Service Bulletin

SB 221 - January 2007

SUBJECT: 17162 Ford F250/350 4WD Mounting Carton

While holding mount assembly tight to the bottom and side of the vehicle frame scribe hole locations to be drilled at "B" and "C" per illustration. FIGURE 1

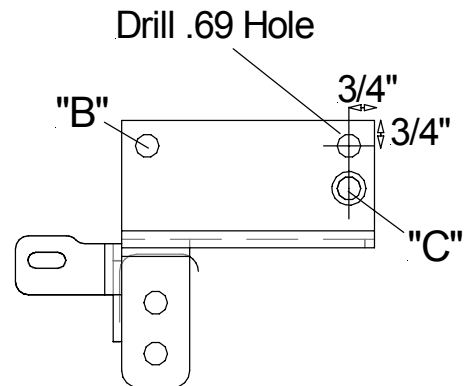
Meyer Engineering has discovered a possible hole alignment issue when installing the 17162 on the Ford F250/F350 driver's side mount assembly P/N 19731 Mount Assembly (driver's side) onto the 2007 vehicle frame. Installation of the mount assembly requires additional holes to be drilled in the vehicle frame.

FIGURE 2

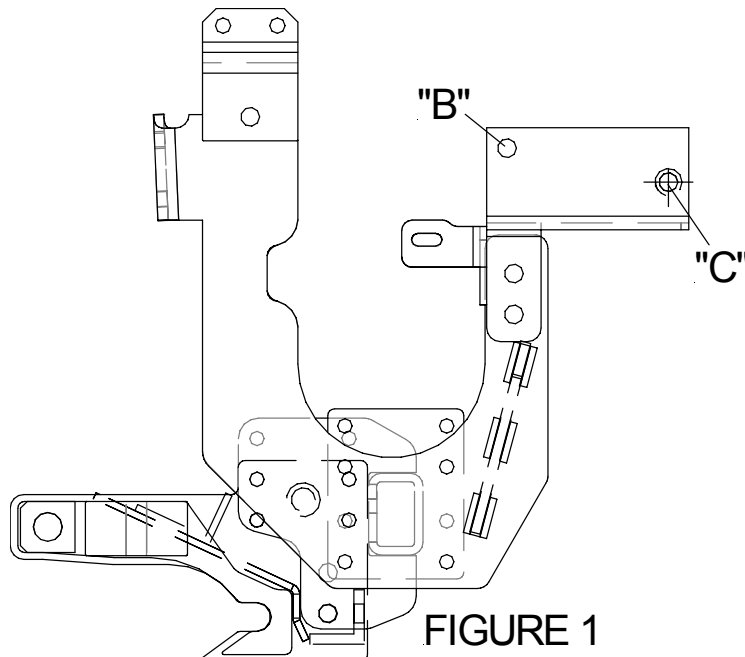
Please take note when scribing hole "C" location. Depending on the individual vehicle frame tolerances, hole "C" in the P/N 19731 mount assembly maybe located too close to the steering gear mounting bolt. If this is the case, drill a new hole in the P/N 19731 mount assembly bracket per illustration FIGURE 2. Repeat steps in Paragraph F using the new hole in mount assembly. Continue to follow the installation instructions on form 1-873 until installation is complete.
